**HIGGINS CANYON ROAD BRIDGE AT MILLS CREEK
EMBANKMENT AND WINGWALL REPAIRS PROJECT**

**COUNTY PROJECT NO. RW909
PROJECT FILE NO. E5003**

ADDENDUM NO. 1

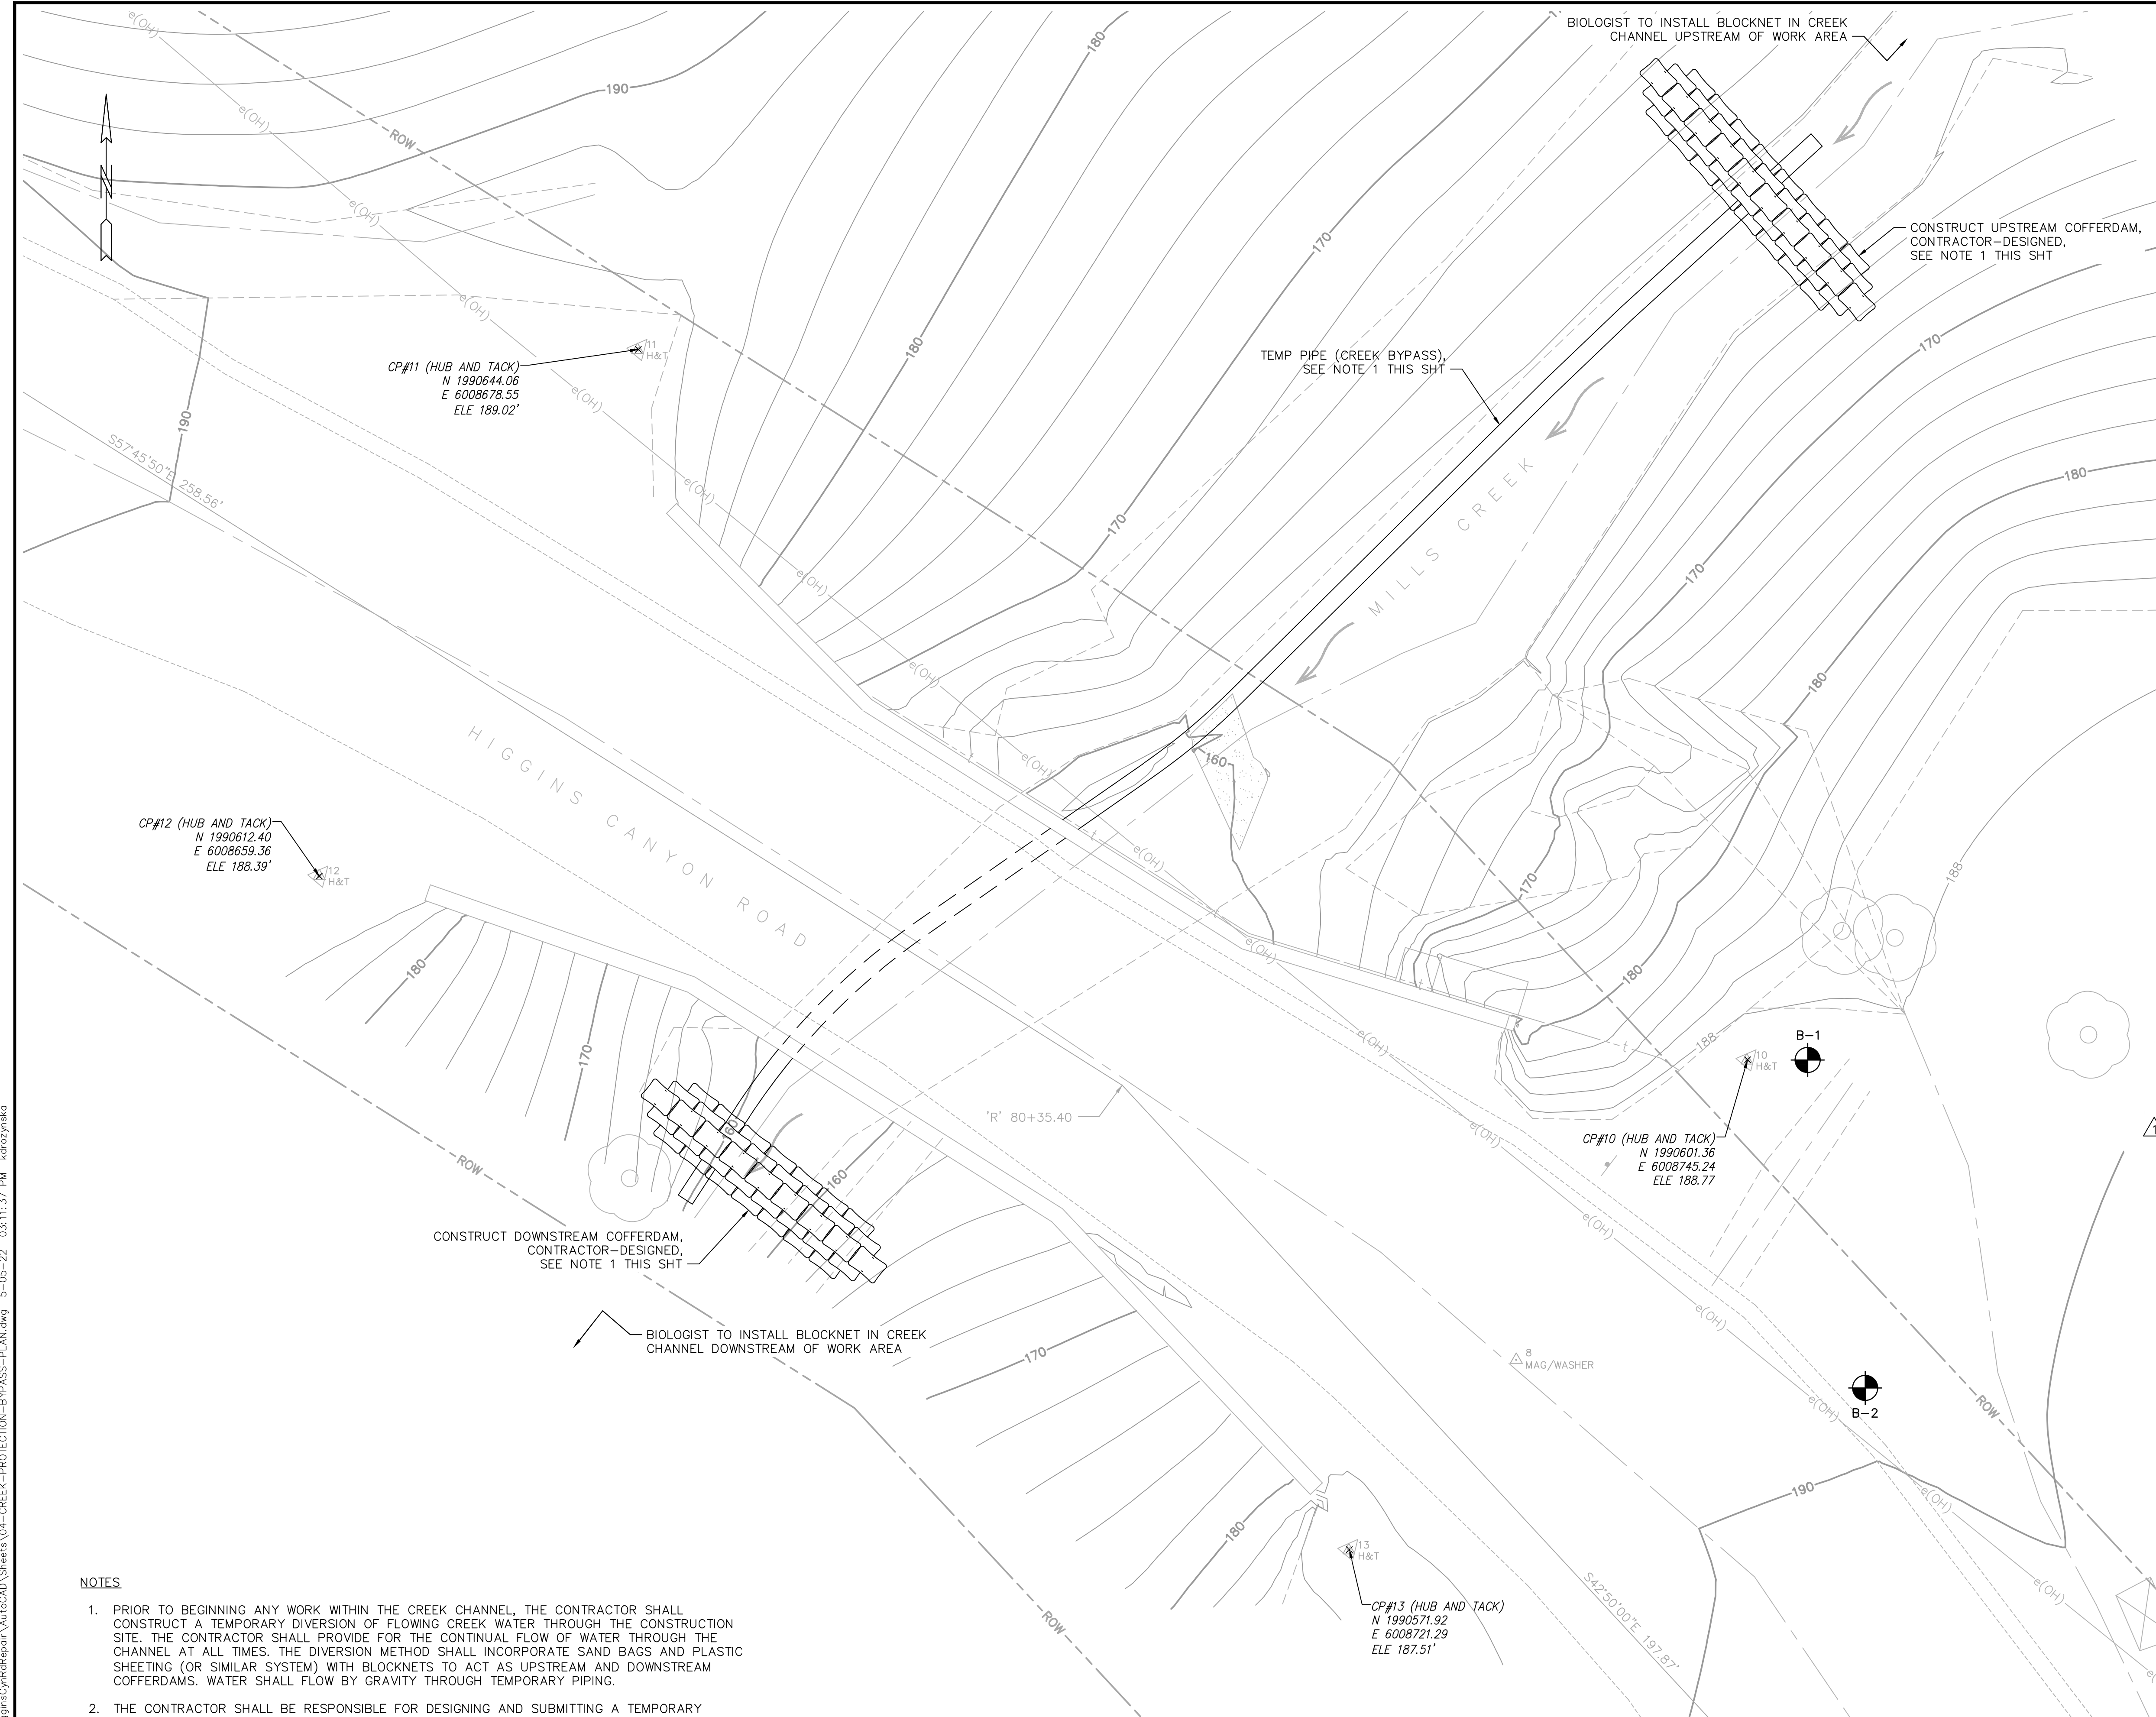
1. Sheet 4 shall be replaced in the Project Plans:

Replace Plan Sheet 4 of 20 with Sheet 4 of 20 (REV).

- THE DIVERSION SHALL BE CAPABLE OF CONVEYING A MINIMUM OF 10 CFS (ADULT HIGH FLOW) WITH LESS THAN 6 INCHES OF HEAD OVER THE TOP OF PIPE AT THE INLET, AND SHALL BE A MINIMUM DIAMETER OF 10", WITH A MANNING'S ROUGHNESS NOT EXCEEDING .012.
